**PLANNING COMMISSION AGENDA
CITY OF PRAIRIE VILLAGE
TUESDAY, AUGUST 3, 2021
7:00 P.M.**

PC2021-117 Preliminary Development Plan and Final Development Plan Applications
Meadowbrook Shopping Center
5300 W. 95th Street
Zoning: CP-1
Applicant: Patrick Reuter, Klover Architects

TO: Prairie Village Planning Commission
FROM: Chris Brewster, Gould Evans, Planning Consultant
DATE: August 3, 2021, Planning Commission Meeting

Request: Revised Preliminary / Final Development Plan – exterior remodel

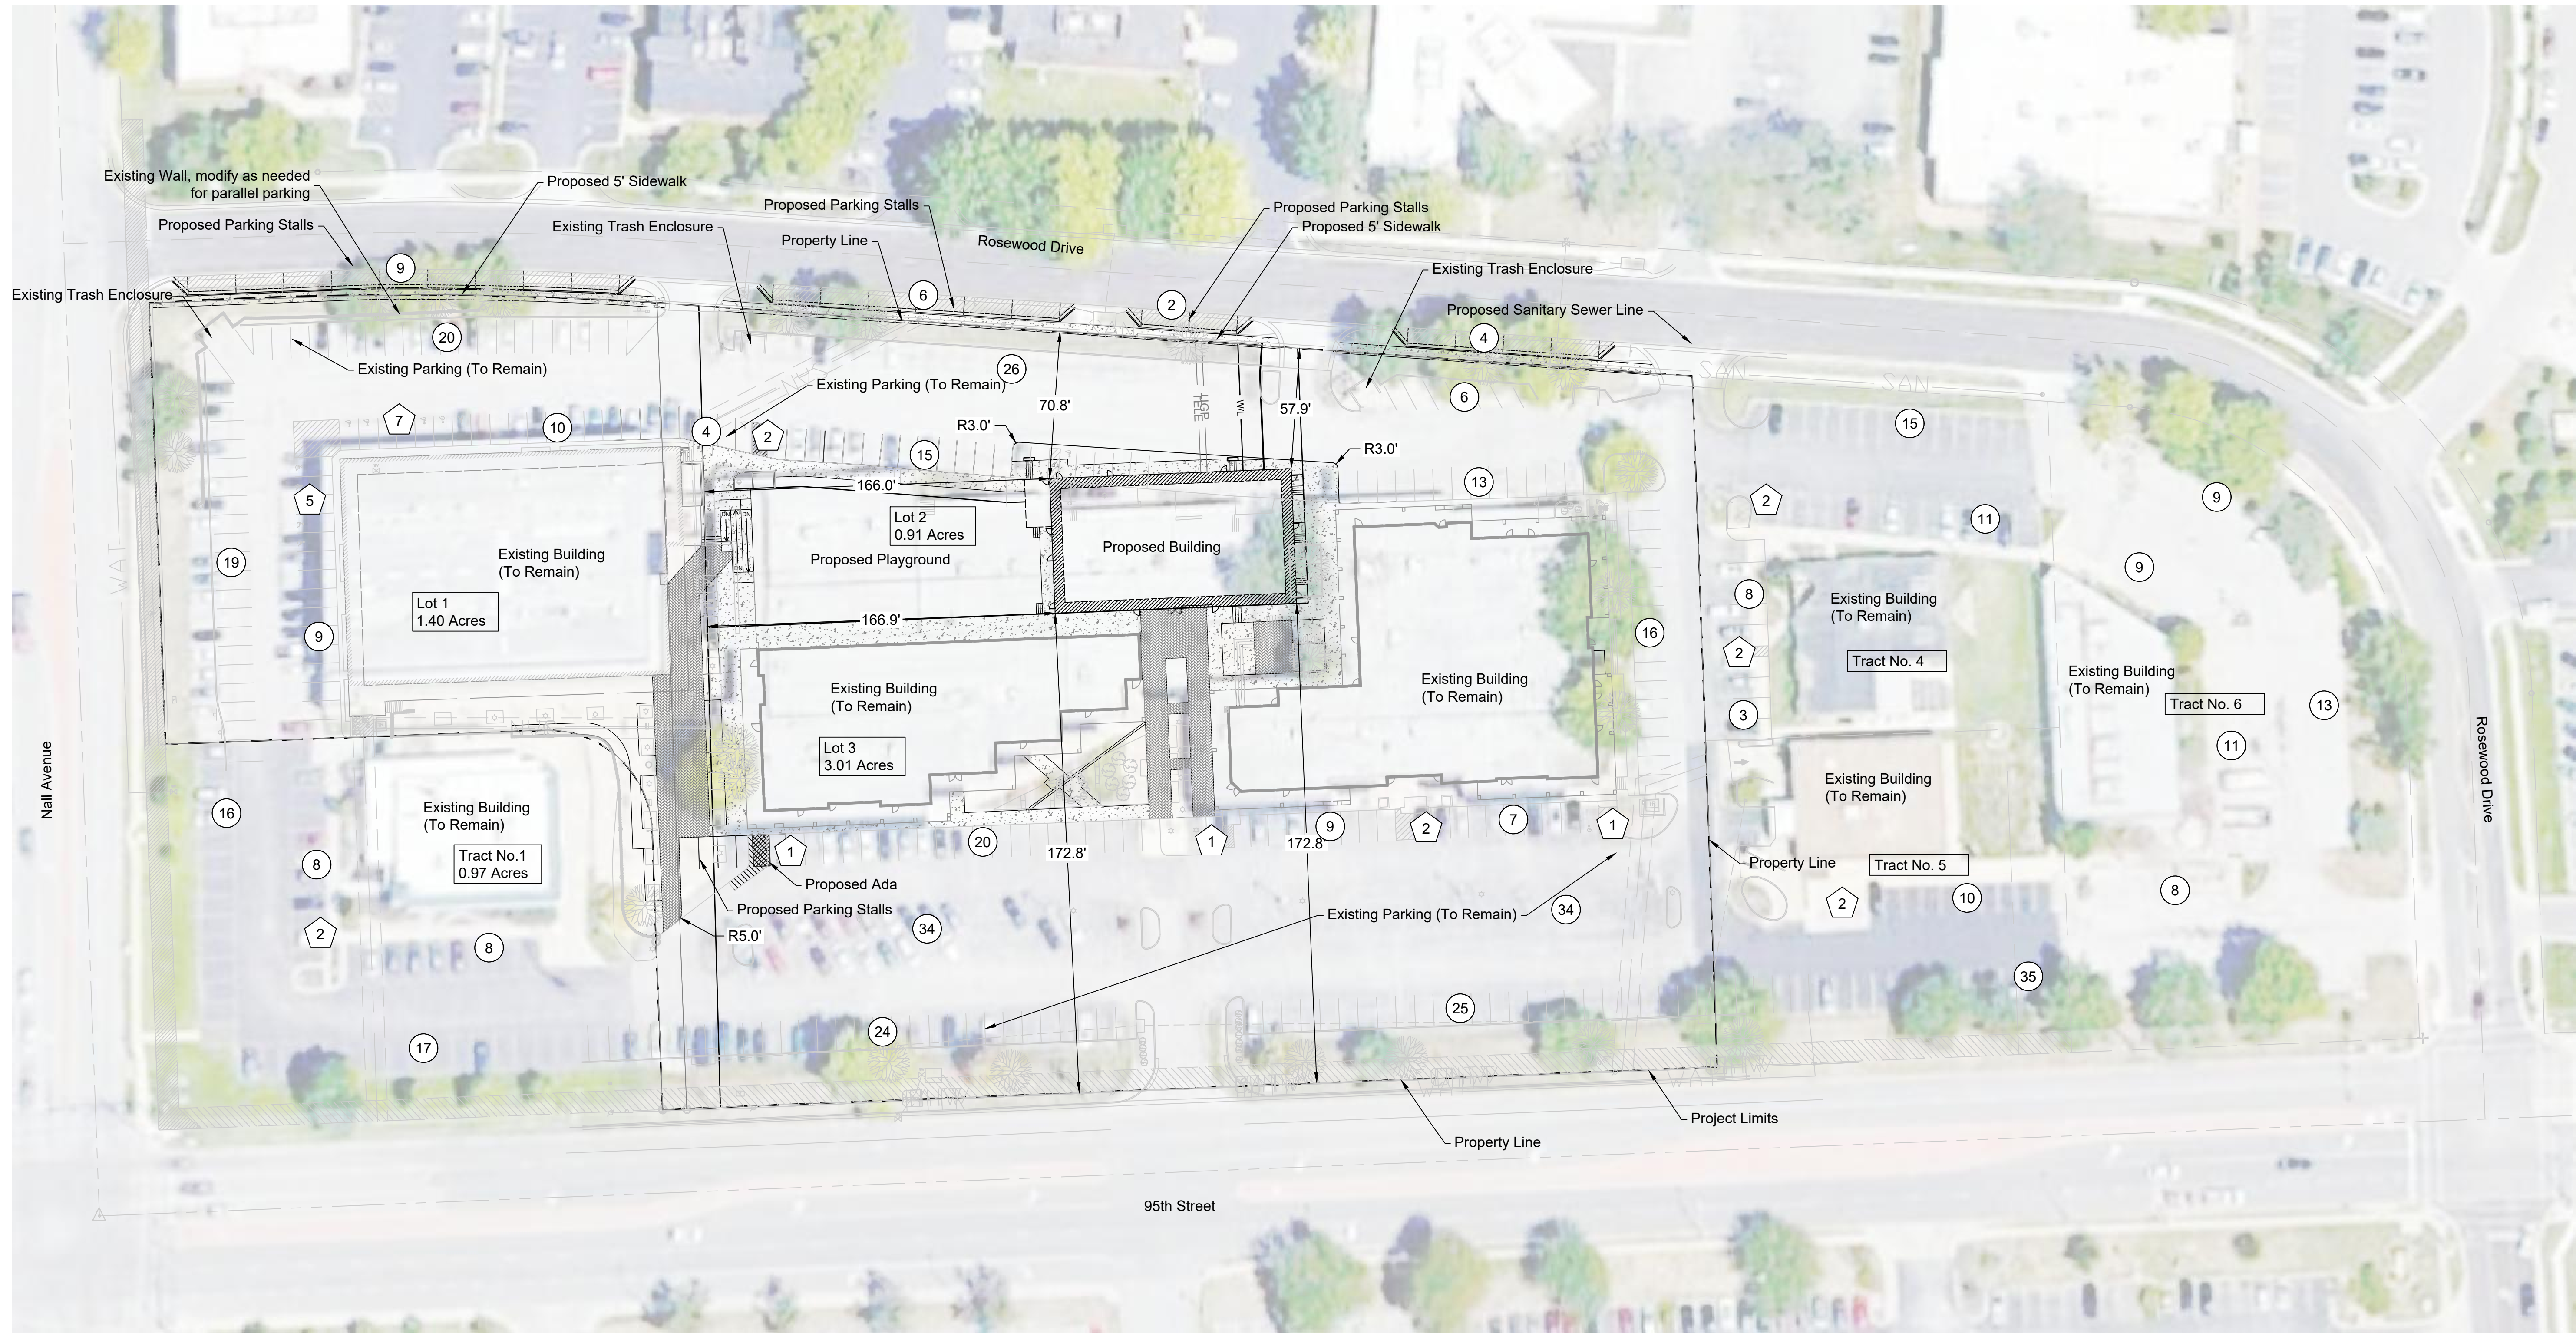
The location and configuration of new Building H will remove approximately 13 on-site parking spaces. Despite this, the site remains adequately parked according to the zoning ordinance.

Additionally, the applicant is proposing 21 additional on-street parking spaces on the south side of West 94th Street on the north side of the project. Planning staff is in support of these proposed parking areas provided appropriate streetscape (sidewalks and street trees) are maintained and Public Works reviews and approves of the parking and specific construction plans. The site is part of a larger commercial development with shared parking and cross access easements, so we do not feel this on-street parking is essential, but can contribute to any overflow parking in the area, and begin to implement some of the larger and longer-term changes to this area identified in the plan. Additionally, 94th Terrace has had recent basic improvements to the streetscape, which would be reconstructed if the on-street parking is included as proposed. Planning staff would recommend three options, dependent on coordination with Public Works:

1. Implement the on-street parking by striping within the current street configuration, leaving the curbs and sidewalks as is; retain the existing street trees proposed to be removed; and supplement with 3 to 5 additional street trees in the existing landscape area.
2. Implement the on-street parking by striping, leaving the curb as is; reconstruct the sidewalk to provide a wider landscape median; and plant new street trees within this widened median between the two access points.
3. Forego on-street parking at this time, or until coordination can occur with future larger-scale redevelopment of the area.

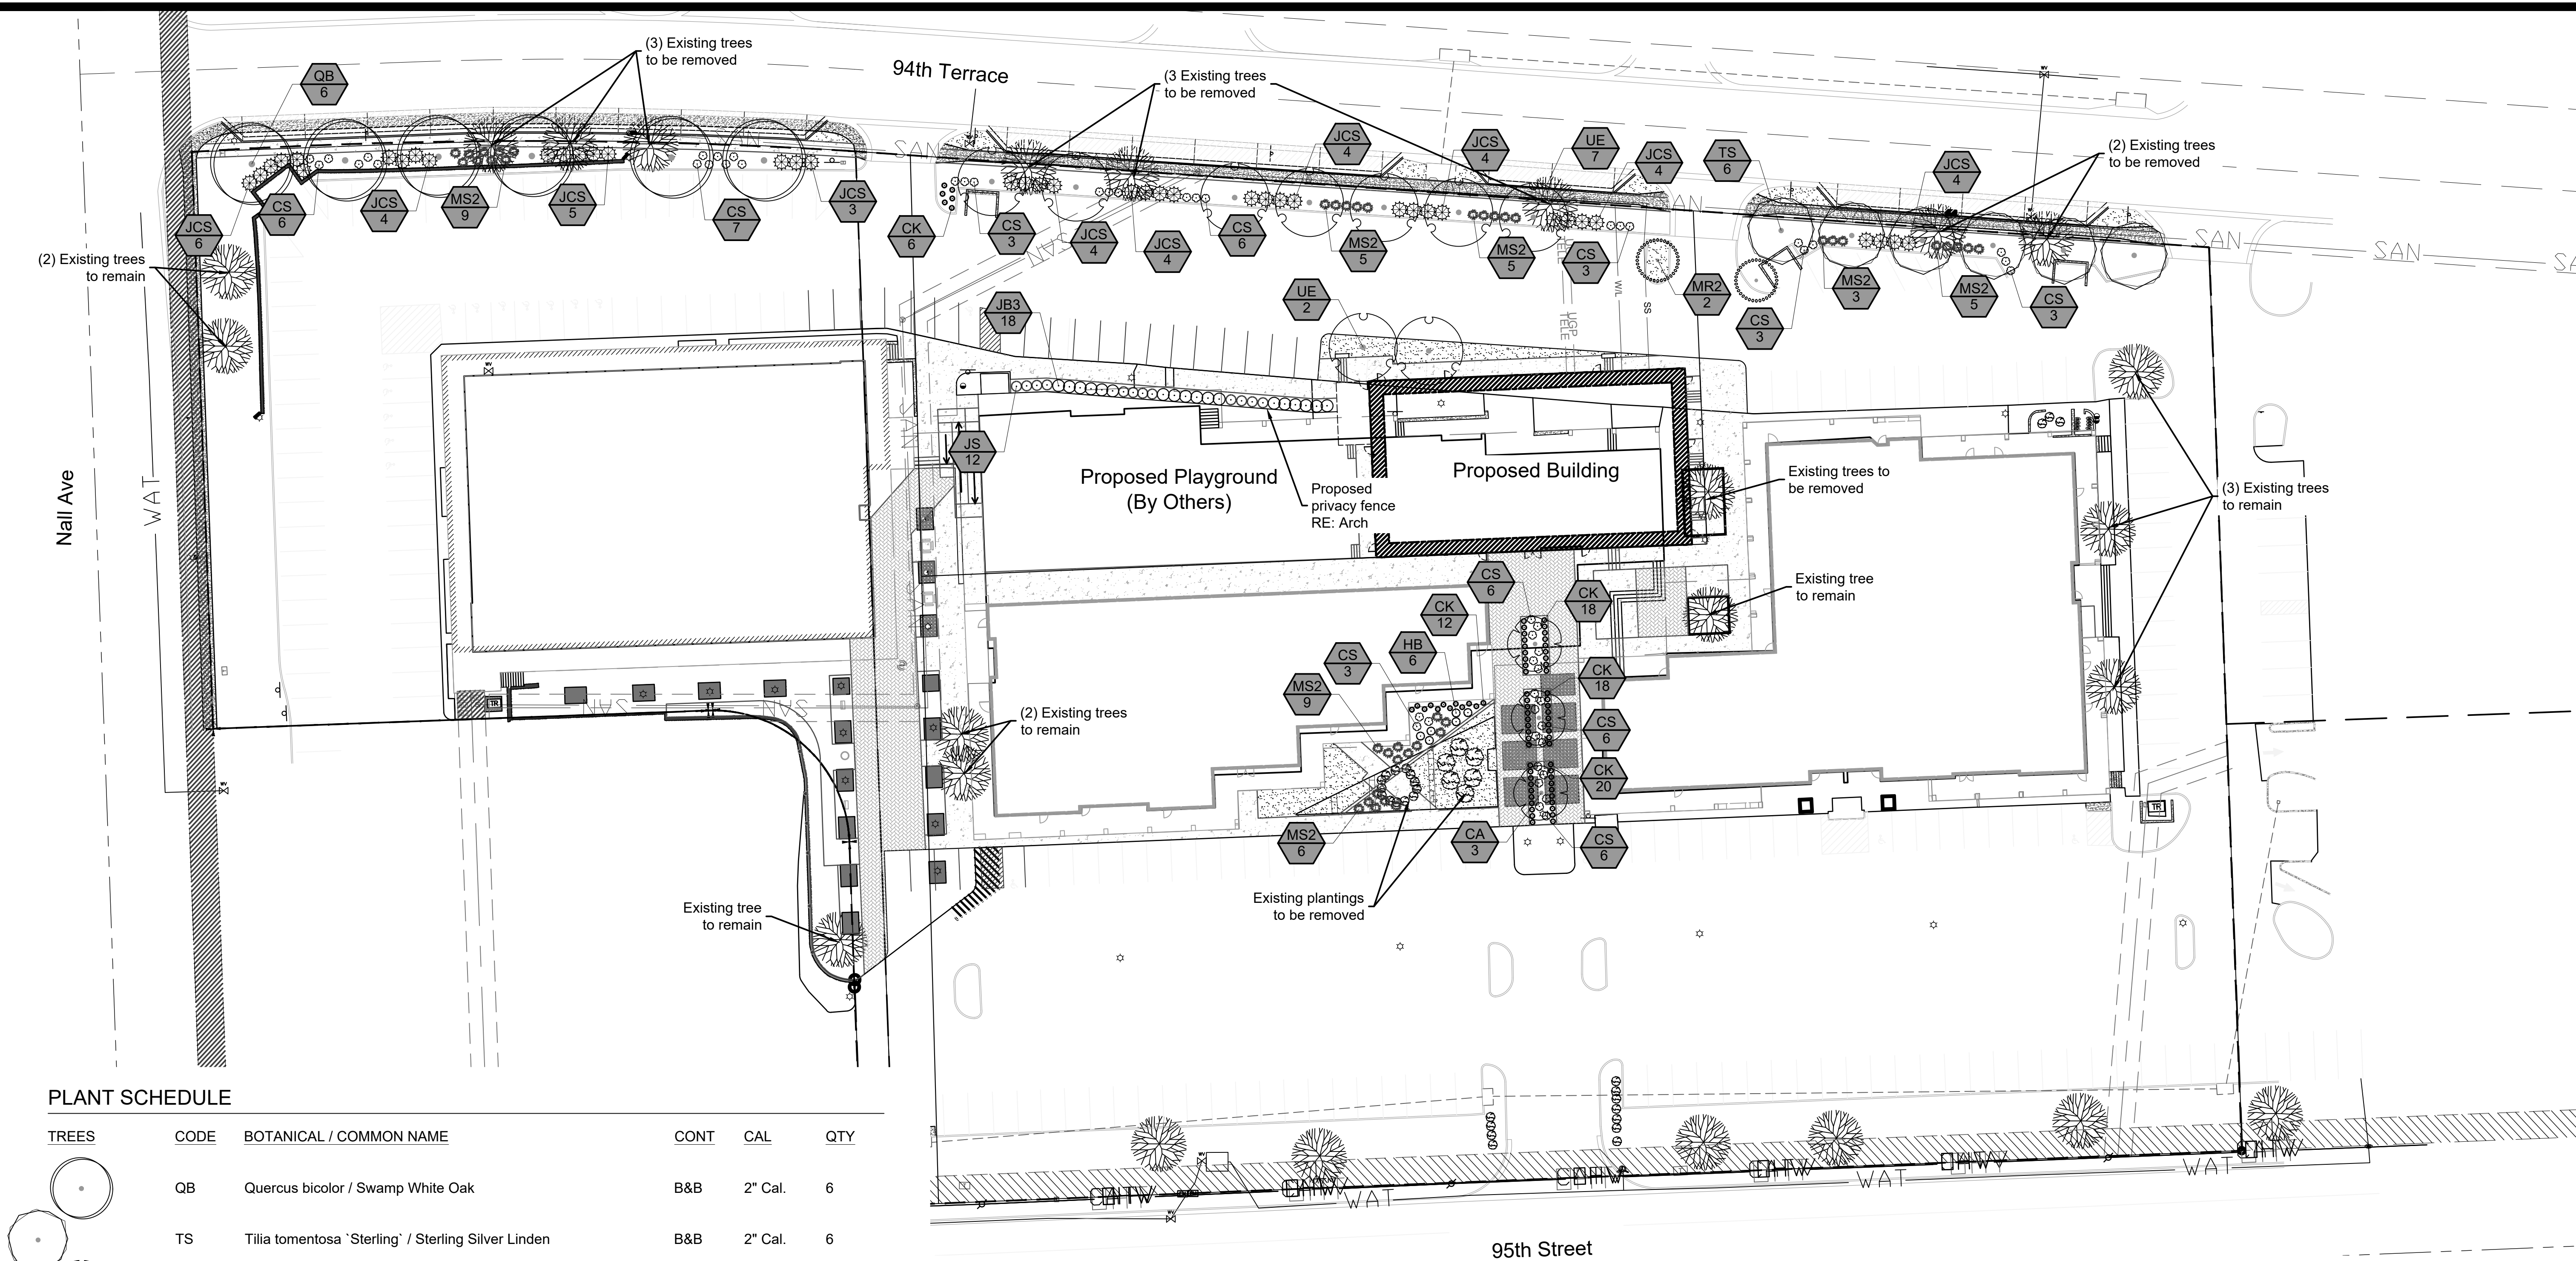
The landscape ordinance applies to all applications requiring site plan review [19.47.010.(b)] For infill development, it is reasonable to apply the standards to the portion of the property where work is being done, and to the extent the standards can be applied within existing site and building configurations. For this project, this affects primarily the parking and streetscape landscape requirements of the required landscape section [19.47.020]. (The foundation and buffer planting requirements are not applicable due to the layout of the existing buildings and context of the site). Overall, the standards should apply to the mid-portion of this site along both 94th Terrace and 95th Street.

Required	Planned
Street Trees		
W. 94 th Terrace	19	19 (but see options related to on-street parking discussion above)
W. 95 th Street	13	5 (existing)
Parking Perimeter		
North Lot (W. 94 th Street side)	Trees (see street trees) 96 shrubs	0 106 shrubs
South Lot (W. 95 th Street side)	Trees (see street trees) 85 shrubs	0 0 shrubs (but several existing associated with entry landscape)
Parking Interior	n/a – not reconfiguring internal parking lots	
Foundation	n/a – not reconfiguring buildings and perimeter landscape	
Buffer	n/a – buffer requirements do not apply to this site

Based on staff review, the landscape plan is missing the following elements required by the ordinance (these primarily result from not addressing the 95th Street side of the landscape plan):

1. Prior to building permits, the landscape plan be amended and approved by staff with the following changes:
 - a. The street trees on W. 94th Terrace be coordinated with the options and direction on on-street parking in condition 2 below.
 - b. Additional shrubs or perennial plants be allocated to the four trash enclosure areas on W. 94th Terrace.
 - c. 8 street trees (or acceptable alternates) be added to the 95th Street frontage, along with preserving the 5 existing street trees.

- d. Approximately 65 to 70 shrubs be added to the parking perimeter along 95th Street, along with preserving the existing shrubs at the entry.
 2. On-street parking on W. 94th Terrace is subject to further review and approval by Public Works, and 3 alternative options should be considered:
